UNITED STATES PATENT AND TRADEMARK OFFICE

APPLICATION NO.	FILING DATE	FIRST NAMED INVENTOR	ATTORNEY DOCKET NO.	CONFIRMATION NO.
10/698,682	10/31/2003	Greg Franke	200315010-1	3560

Office Action Summary	Application No. 10/698,682	Applicant(s) FRANKE ET AL.	
	Examiner Corey M. Broussard	Art Unit 2835

Fig. 1

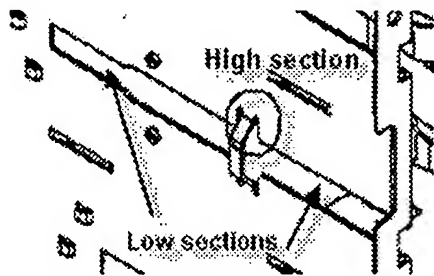
11. With respect to claim 19, Chen teaches wherein the first slot is nonlinear and comprises a first and second low sections disposed at the opening and the termination, respectively (see present Office Action Fig. 1 below, taken from Fig. 4 of Chen),

and a high section disposed between the first and second low sections (see present Office Action Fig.1 above), the high section clearing the profile of the media drive when the media drive is fully inserted in the cage such that air may flow through the high section into or out of the cage, unimpeded by the media drive.
